KWM-380

Service Bulletins

AC-3803 CONTROL INTERFACE KIT (641-7150-001)
CONTROL INTERFACE CIRCUIT CARD (638-6910-001)

SERVICE BULLETIN NO 1

Low-Pass Filter Card A15
Figure 2

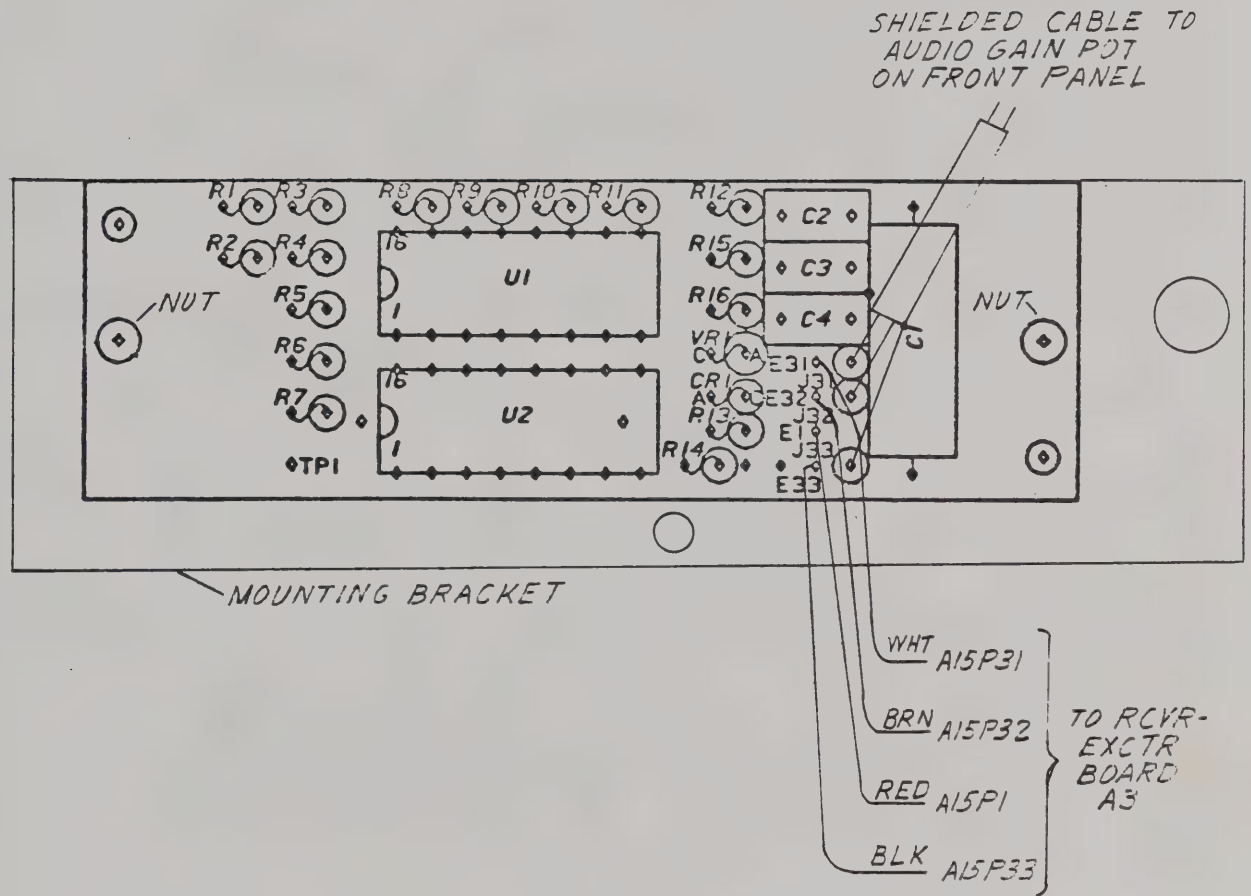
- D. Install filter circuit card A15 (646-5802-001) onto mounting bracket (647-2929-001) using two hex nuts (333-1299-000). Refer to figure 2.

P/O Receiver-Exciter Card A3
Figure 1

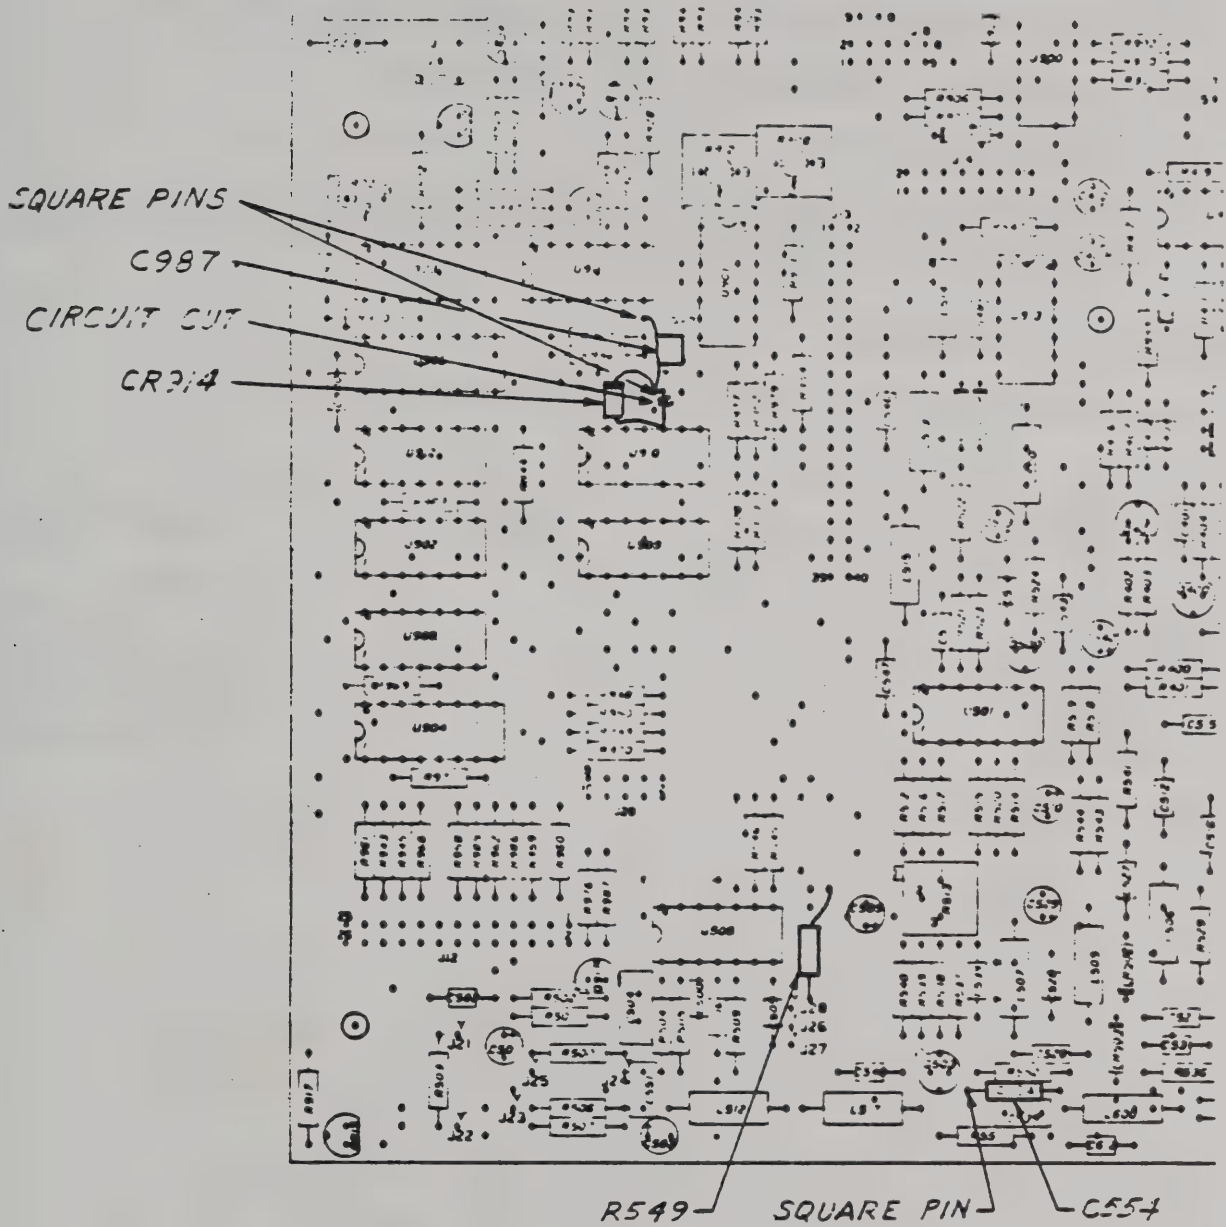
- M. Install 33-k Ω resistor R549 (745-0803-000) as shown in figure 1.
- N. Mark RWK REV R on the A3 circuit card near the existing REV letter.
- O. Plug the cables in that were removed in steps C and D.
- P. Reinstall the dust cover.
- Q. Mark SB 12 on the service bulletin information chart. If the transceiver does not have an information chart (280-3778-010), order one and attach it near the nameplate.

Directional Coupler/TR Relay A2A2
Figure 1

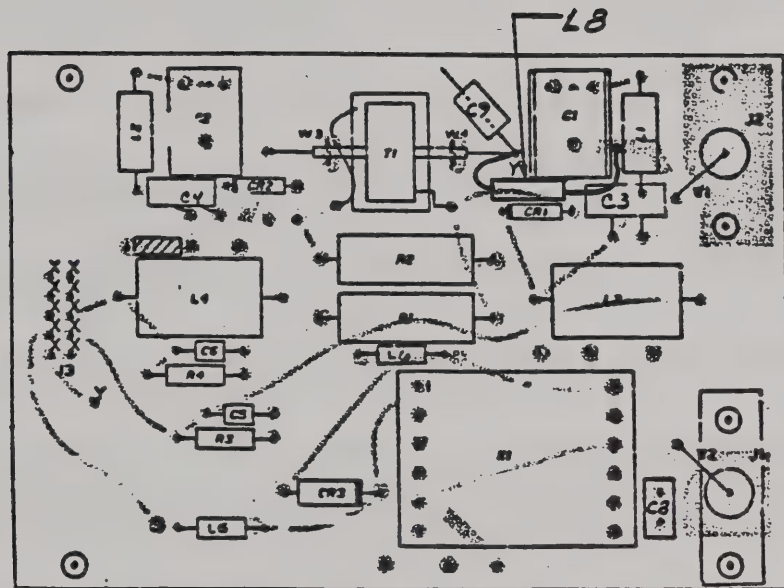
F. Refer to figure 1. Install 220- μ H choke L8 (240-2524-000) as follows:

This modification adds a choke on directional coupler circuit card A2A2 to provide an antenna static discharge path. This will greatly reduce the possible loss of directional coupler diodes in the field.

P/O Receiver-Exciter Circuit Card A3
Figure 1

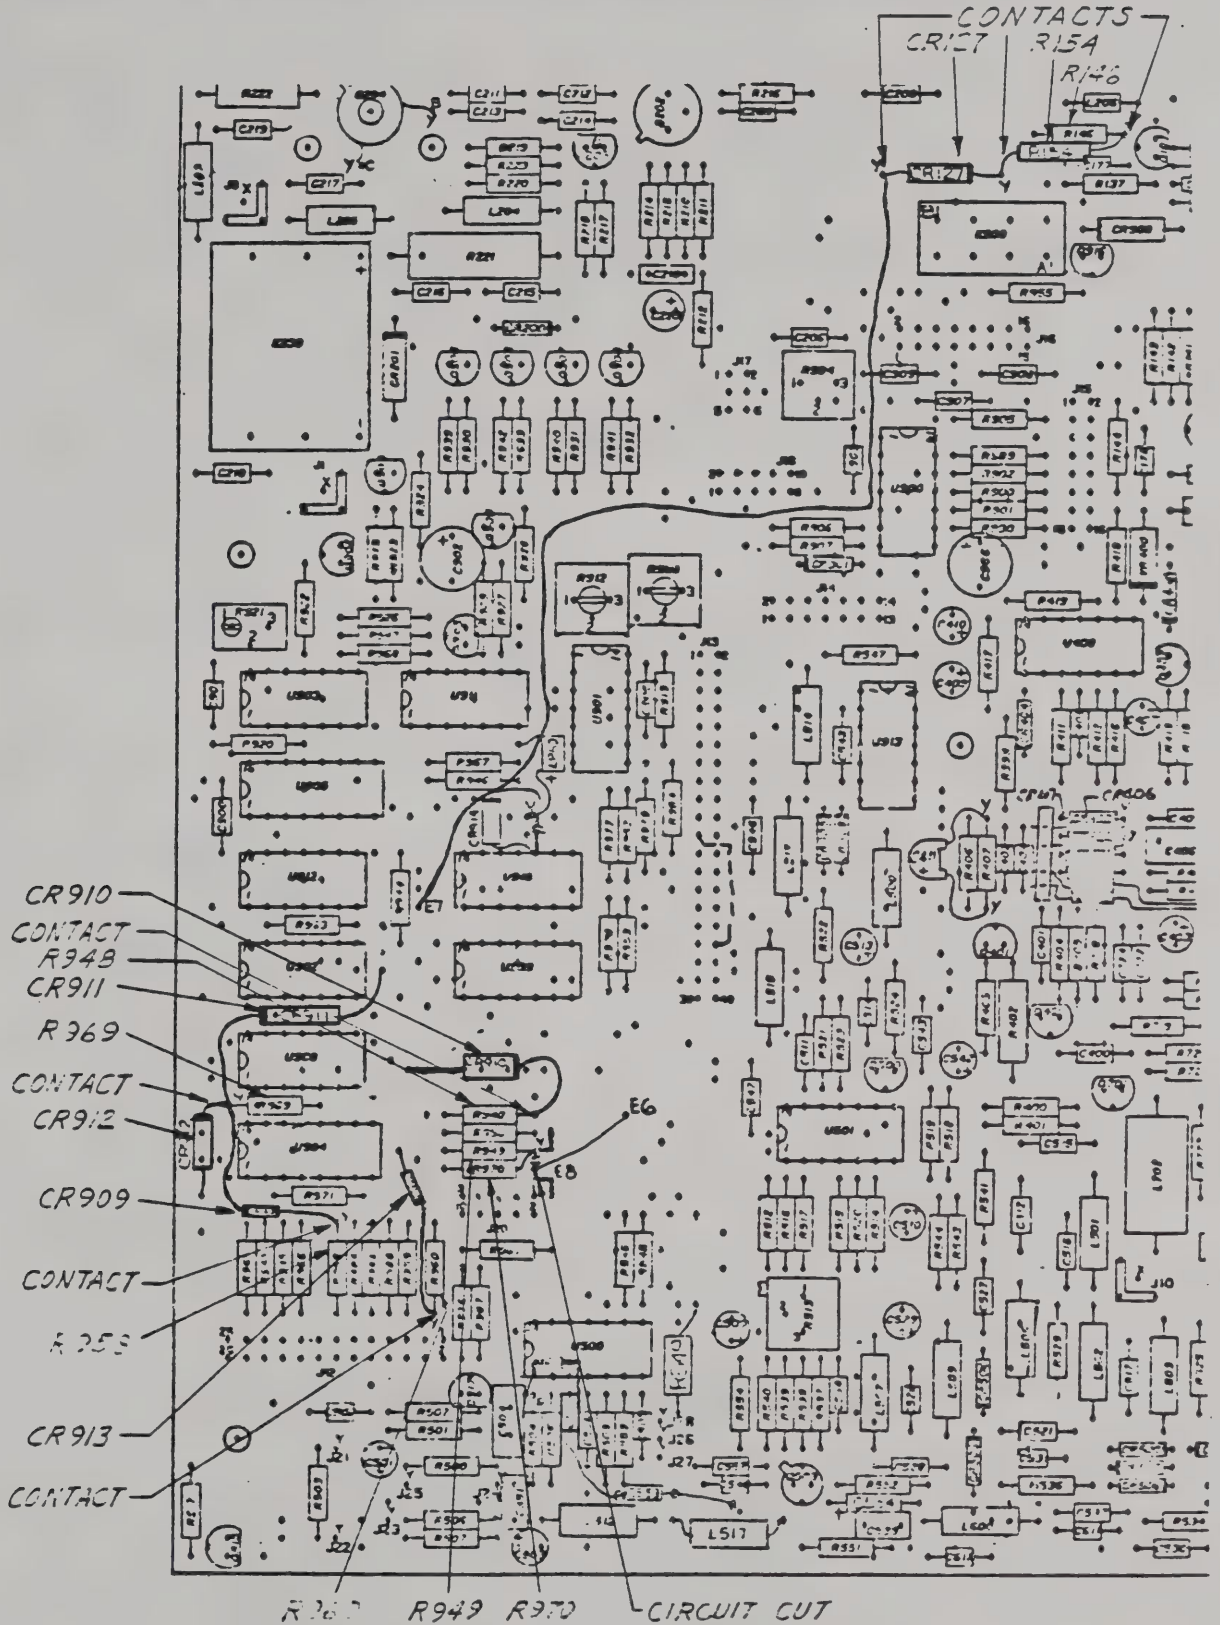
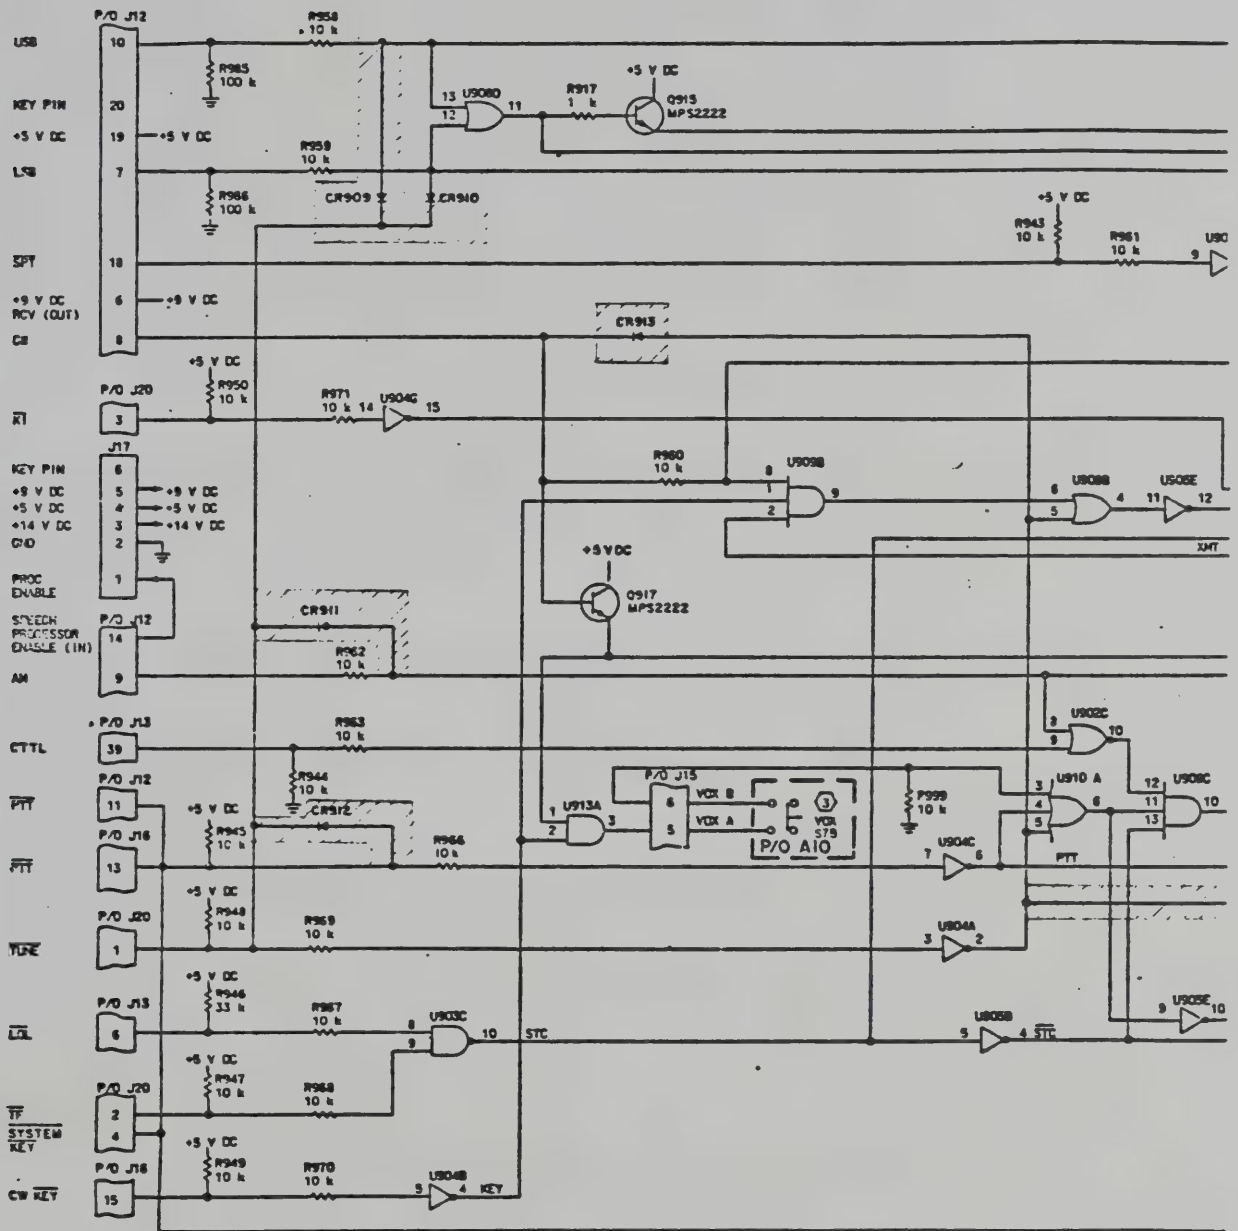
- D. Cut the circuit trace that connects R970 and R949 right-hand leads as shown in figure 1. Cover the circuit trace cut with a nonconductive material such as epoxy.

- H. Install and solder a #30 AWG jumper wire (428-0282-050) from E8 to E6 as shown in figure 1.

- K. Connect the R960 lead to the new contact.
- L. Install 1N4454 diode CR913 (353-3644-010) as shown in figure 1 with the cathode end connected to the contact installed in step J. Solder connections on both ends.

- Q. Install 1N4454 diodes CR911 and CR912 (353-3644-010) as shown in figure 1 with the cathodes connected to R969. Solder all connections.
- R. Unsolder and lift the right-hand lead of resistor R948.

- S. Install and solder a contact (372-2601-045) in the hole where the R948 lead was removed.
- T. Connect the R948 lead to the new contact.
- U. Install 1N4454 diode CR910 (353-3644-010) as shown in figure 1 with the cathode end connected to the contact installed in step S. Solder all connections.

- V. Unsolder and lift the right-hand lead of resistor R146.
- W. Install and solder three contacts (372-2601-045) in the vicinity of R146 as shown in figure 1.

- X. Connect the R146 lead to one of the new contacts as shown in figure 1.
- Y. Install 100-k Ω resistor R154 (745-0821-000) between two of the new contacts as shown in figure 1.

- Z. Install 1N4454 diode CR127 (353-3644-010) as shown in figure 1 with the cathode end connected to R154.
- AA. Install a #30 AWG jumper wire (428-0282-050) from E7 to the anode end of CR127. Solder all connections.

P/O Receiver-Exciter Circuit Card A3.
Figure 1 (Sheet 2)

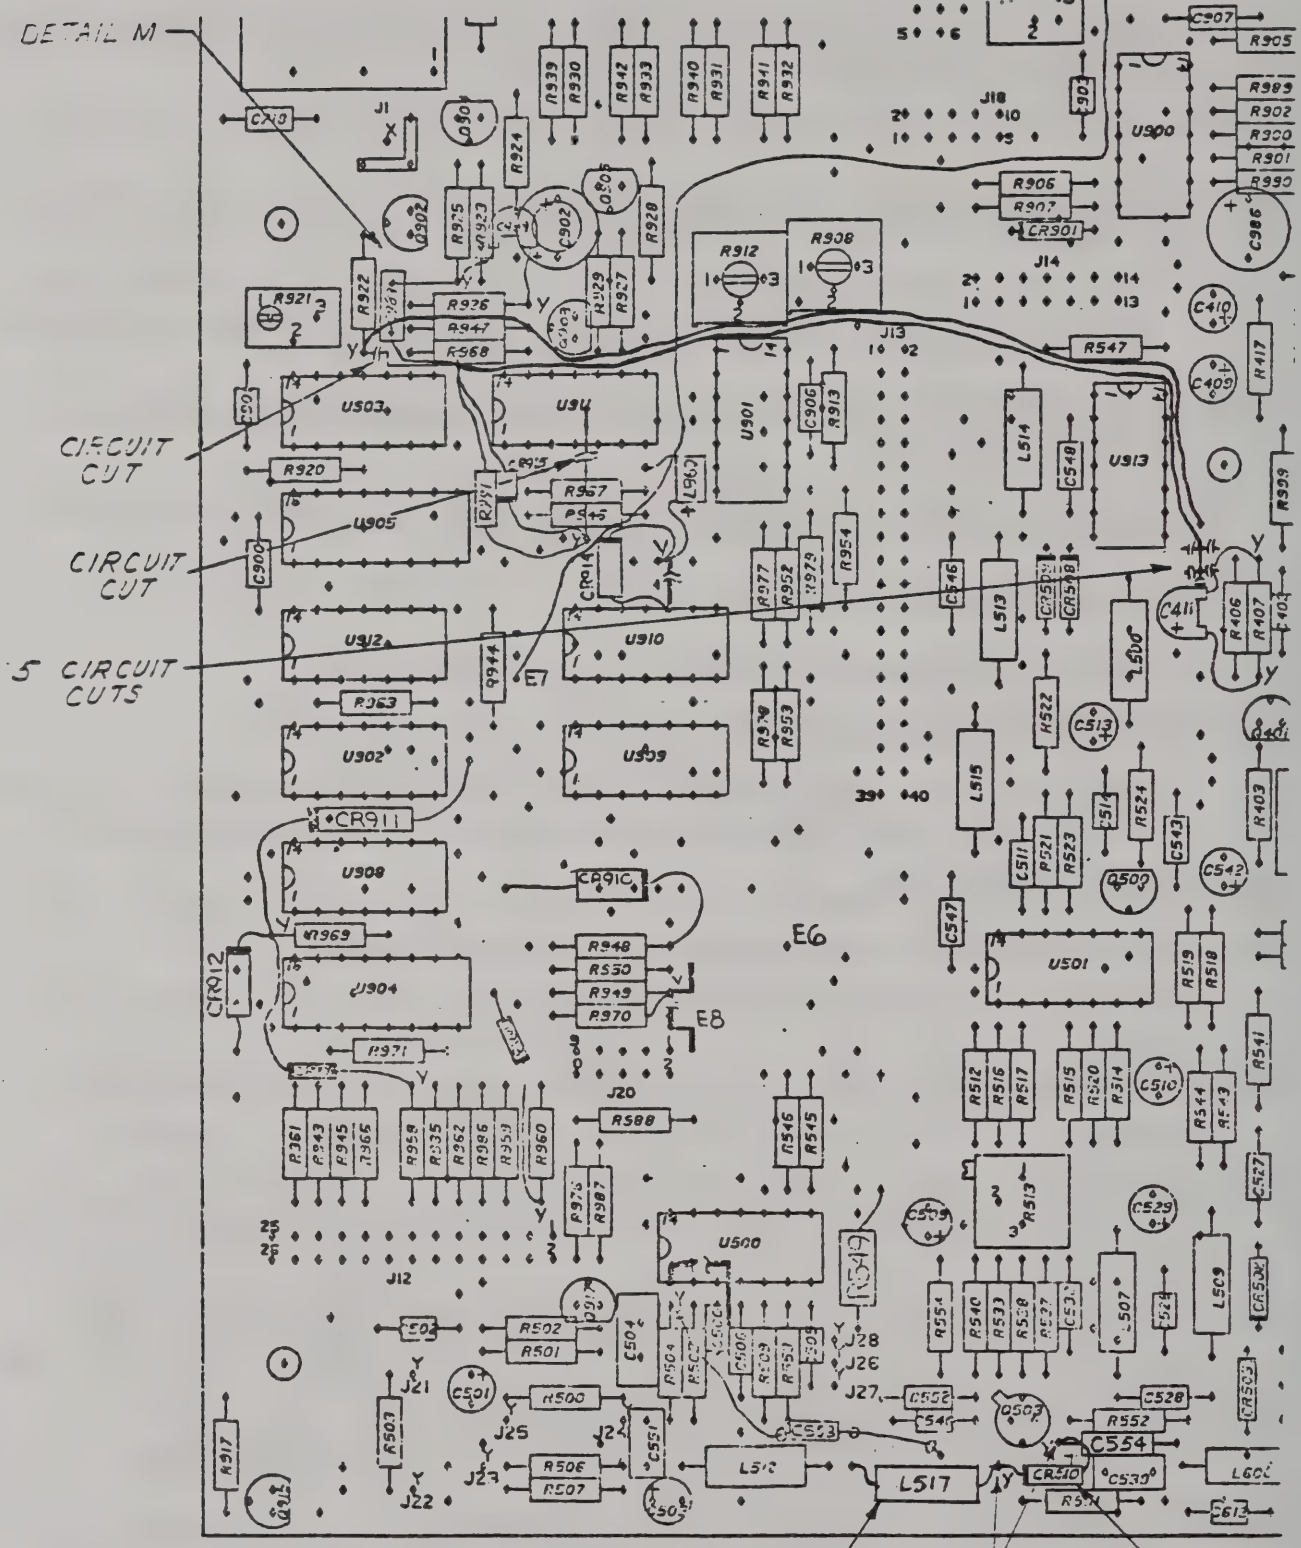
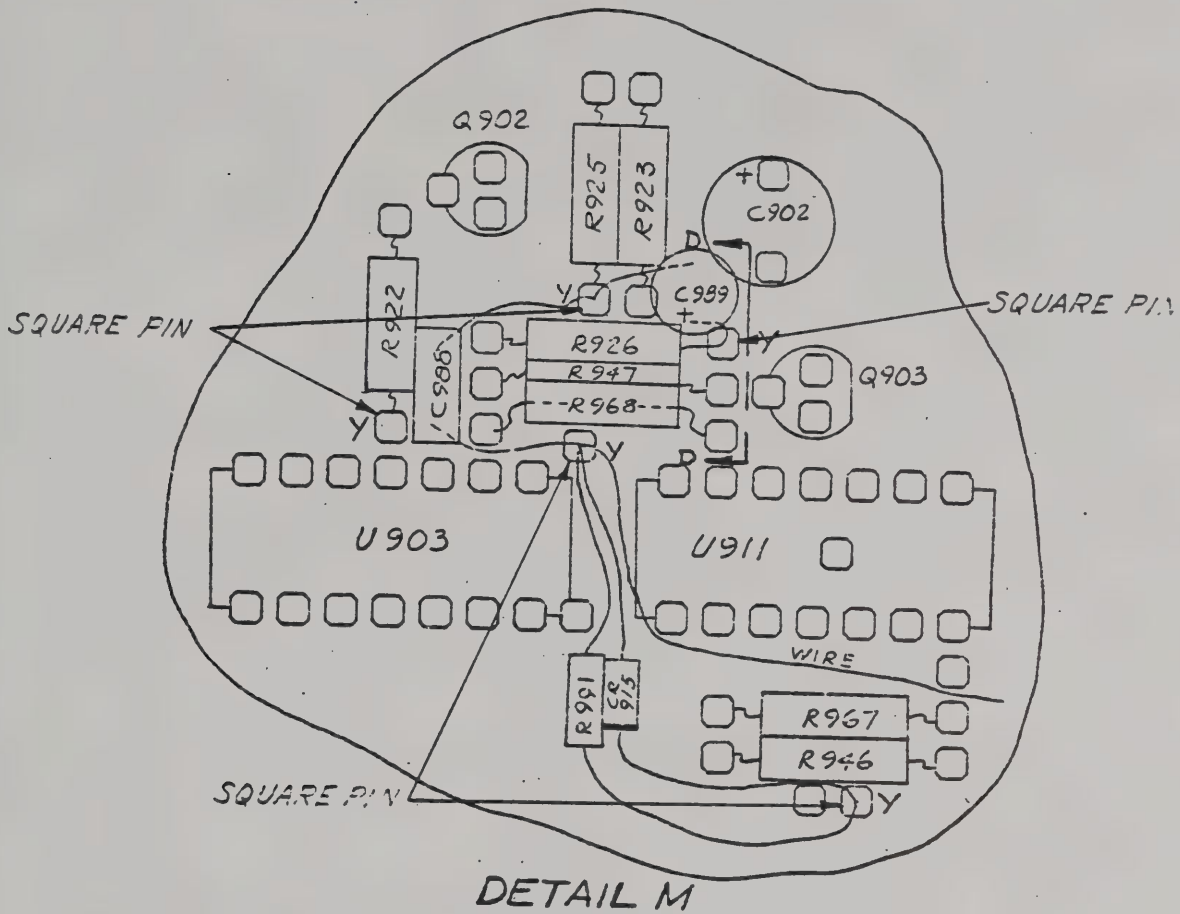
- H. Refer to figure 1, detail M, for location and install five square pins (372-2601-045). Lift component leads, as necessary, and reconnect the leads to the pins after the square pins are installed.

- N. Install 0.1- μ F capacitor C988 (913-5019-440) from the square pin at the bottom lead of R925 to the square pin below R968.
- O. Install 1.5- μ F capacitor C989 (184-9102-800) with the positive lead connected to the square pin at the right-hand lead of R926 and the other lead connected to the square pin at the bottom of R925. Refer to figure 1, detail M, section D-D.
